04	07.02.19	Lights added/deleted/moved as per client comments, see revision clouds; LED strip incorporated on handrails, see revision clouds; bottom grilles have moved down, see revision clouds; MJ amended as per Client and Structural Engineer comments. Notes added on MJ in order to clarify real position; Brick Joints/Wall Lamps/RWP plates have been incorporated on Balconies; Key and Notes have been updated, see revision clouds.	AO
03	12.12.18	Movement joints added as per Walsh drawings; Sliding doors into balconies revised as per client change; General updates in line with updates on external openings.	AO
02	16.02.18	General updates as per revision clouds, material key added to the elevations.	GF
01	13.10.17	Stage 04 Main Building Submission	GF
-	17.05.17	Stage 03 Main Building Pack	GF
REV	DATE	NOTES	INT

JOB TITLE
 Stanley Sidings, 101 Camley Street, Camden

DRAWING TITLE / LOCATION
 North Block Envelope - Lower Levels

DRAWN BY	CHECKED	SCALE	STATUS
GFV	DMV	1:100@A1 / 1:200@A3	STAGE 05
PROJECT	DRAWING NO	REVISION	
16022	N AL 0020 006	04

DRAWN BY	CHECKED	SCALE	STATUS
MH	DMV	1:100@A1 / 1:200@A3	STAGE 05
PROJECT	DRAWING NO		REVISION
16022	S AL 0020 005		04

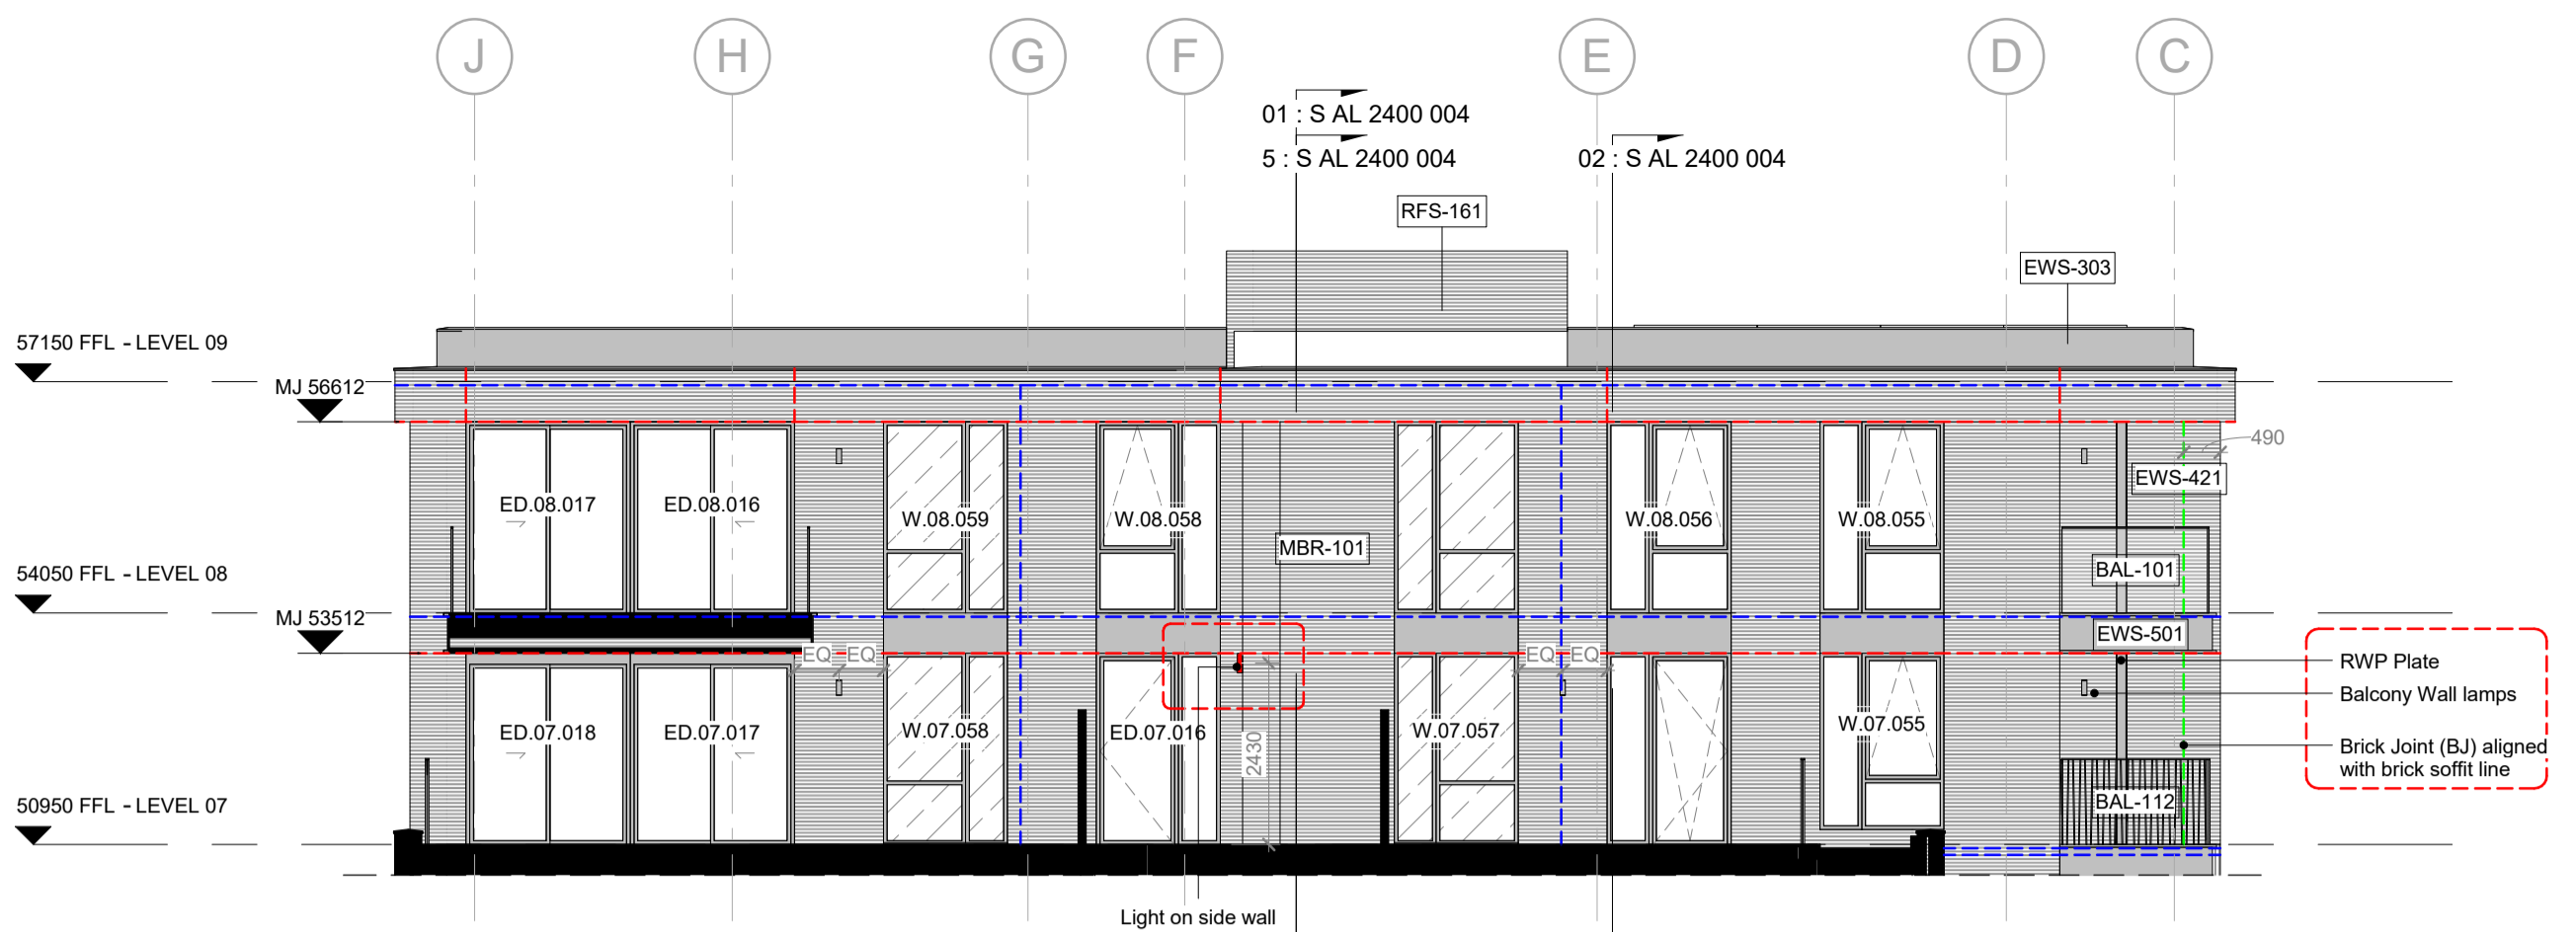
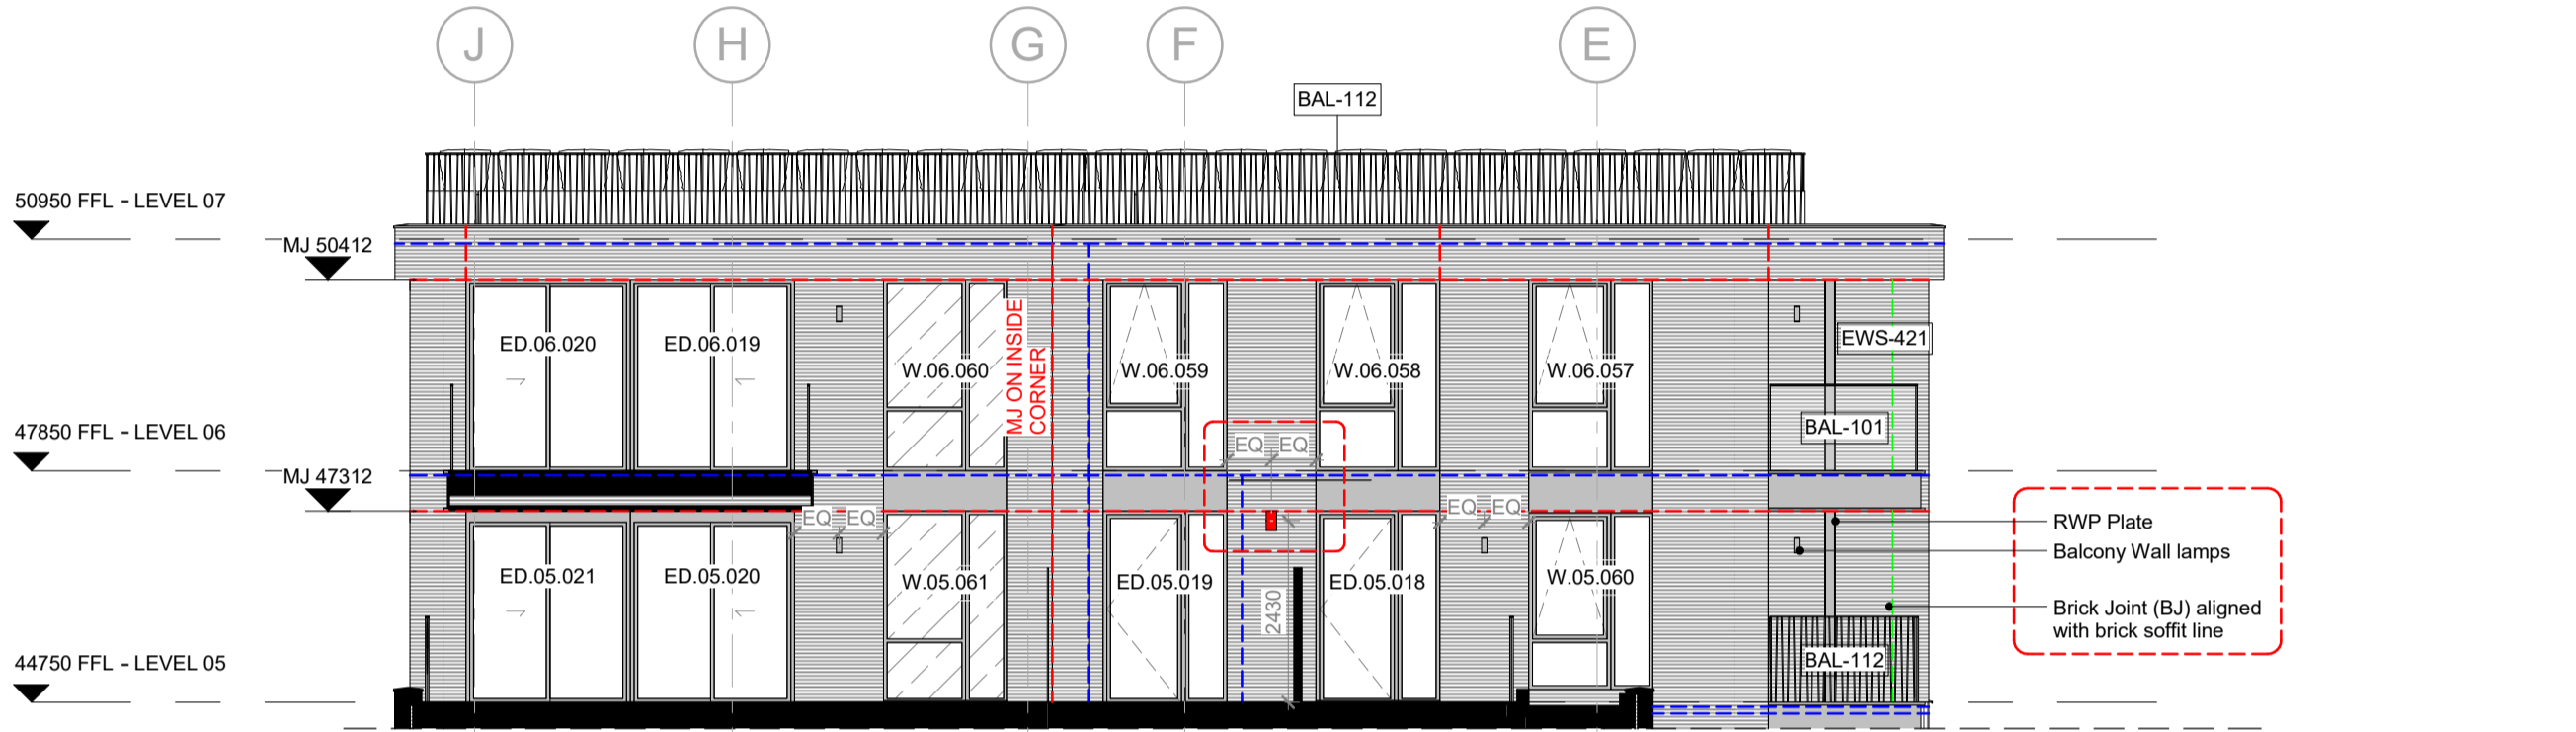
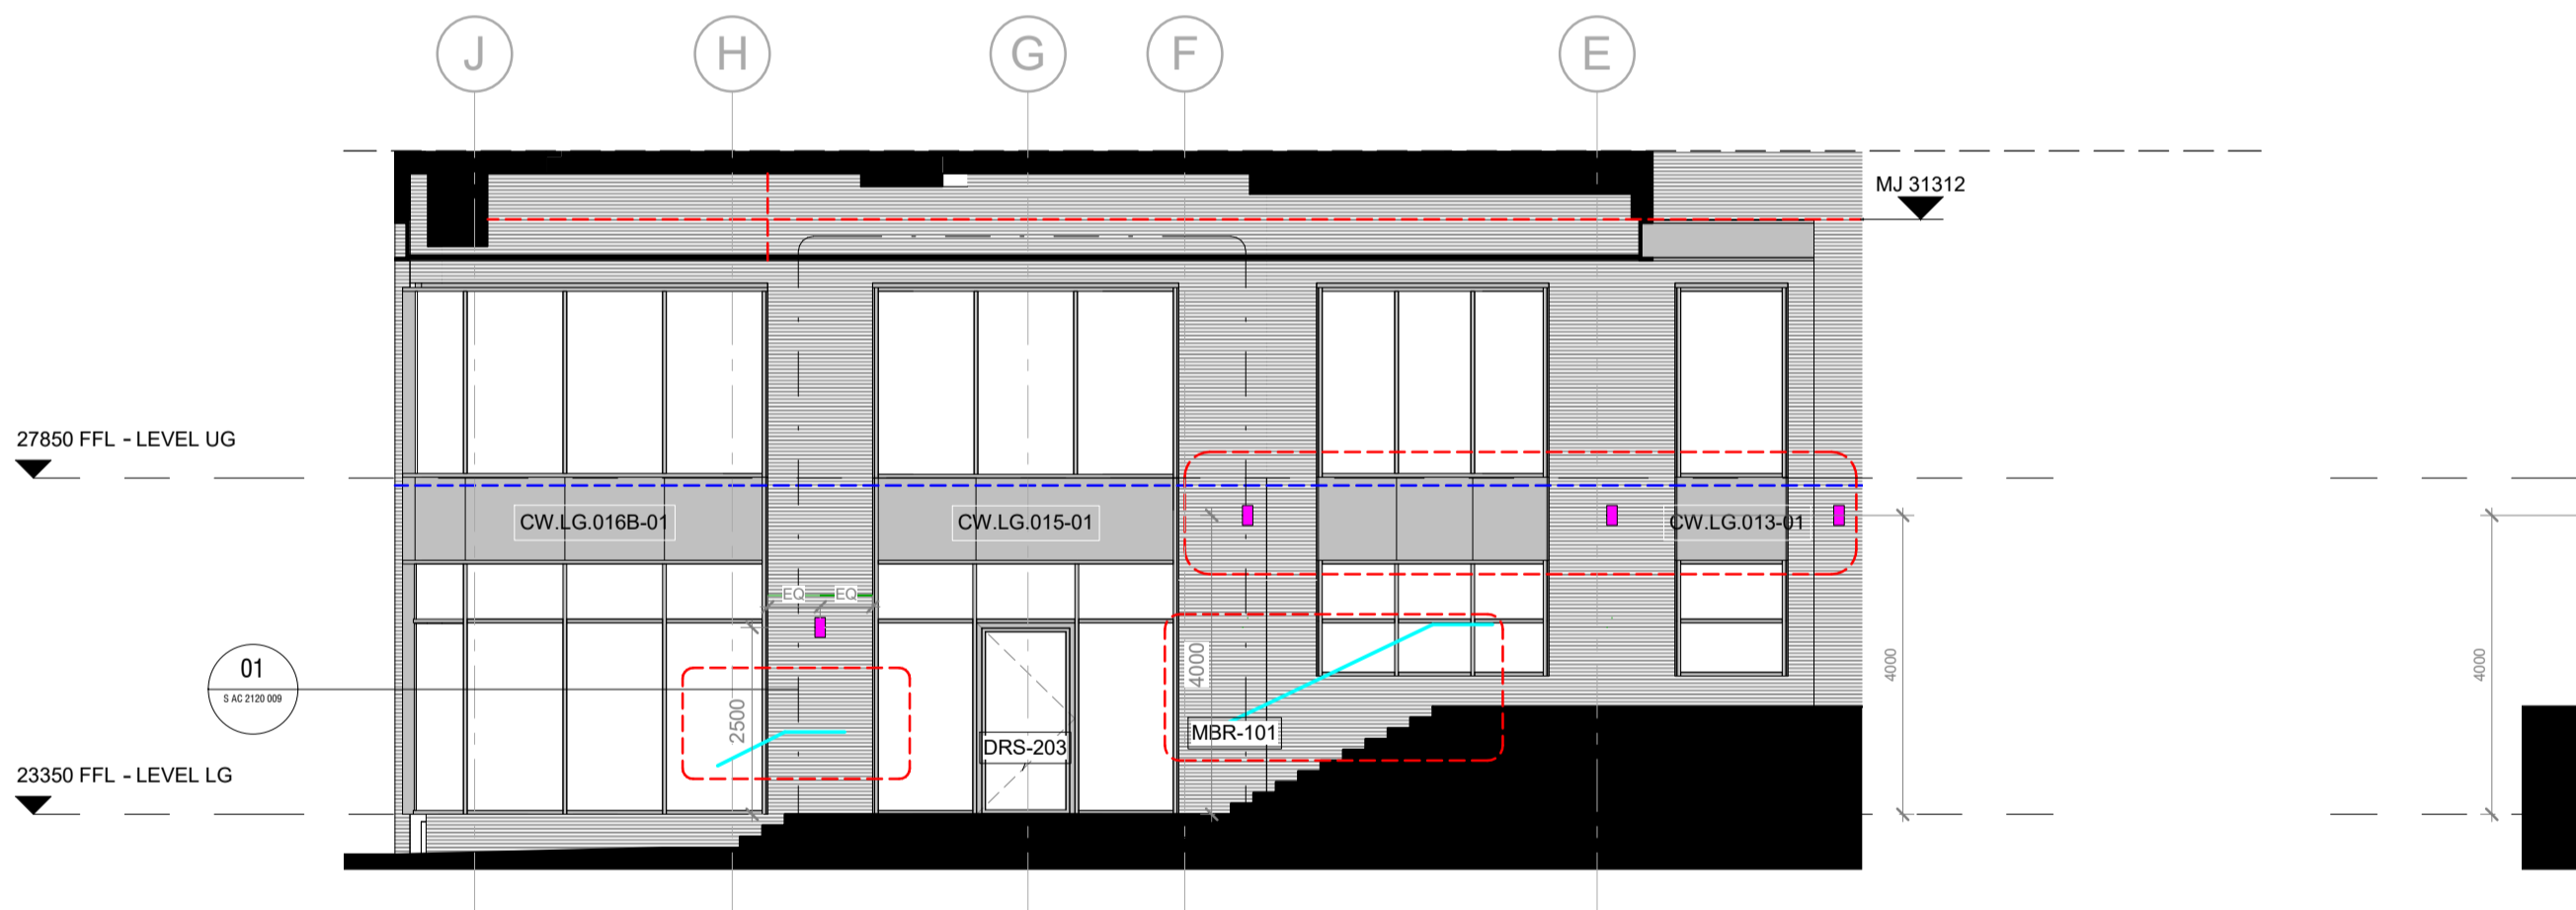
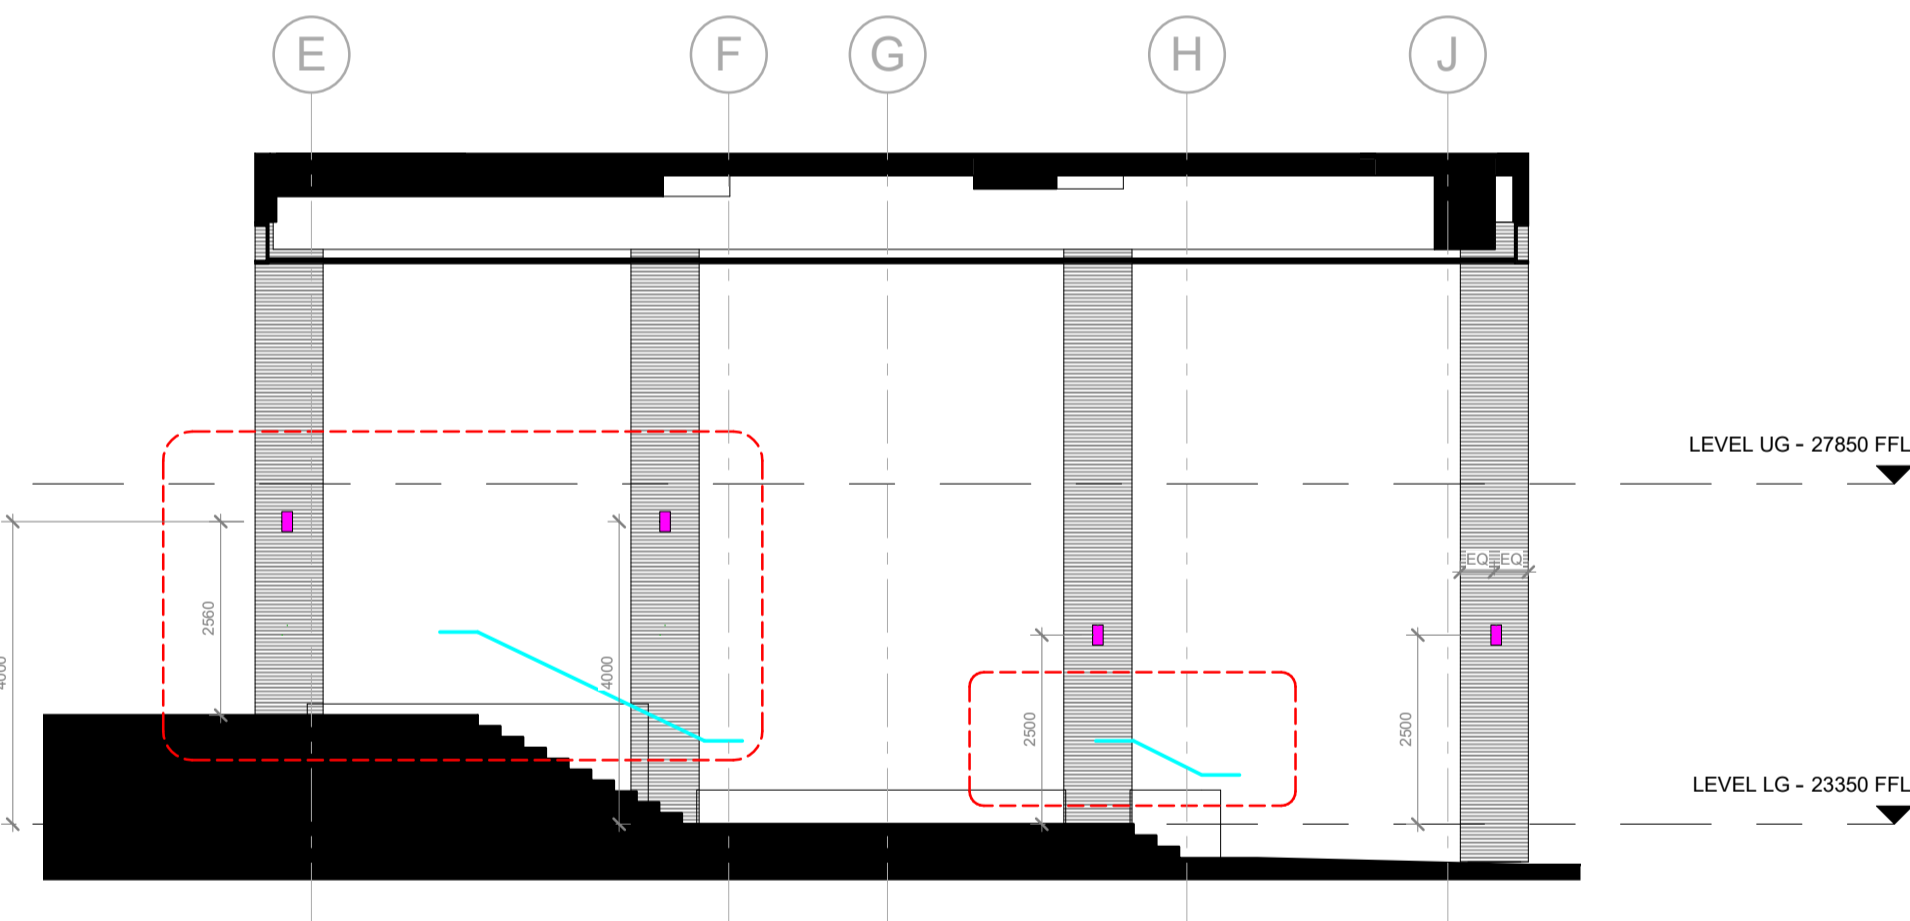
04	07.02.19	Lights added/deleted/moved as per client comments, see revision clouds; LED strip incorporated on handrails, see revision clouds; bottom grilles have moved down, see revision clouds; MJ amended as per Client and Structural Engineer comments. Notes added on MJ in order to clarify real position; Brick Joints/Wall Lamps/RWP plates have been incorporated on Balconies; Key and Notes have been updated, see revision clouds.	AO
03	12.12.18	Movement joints added as per Walsh drawings; Sliding doors into balconies revised as per client change; General updates in line with updates on external openings.	AO
02	16.02.18	General updates as per revision clouds, material key added to the elevations.	GF
01	13.10.17	Stage 04 Main Building Submission	GF
-	17.05.17	Stage 03 Main Building Pack	GF
REV	DATE	NOTES	INT
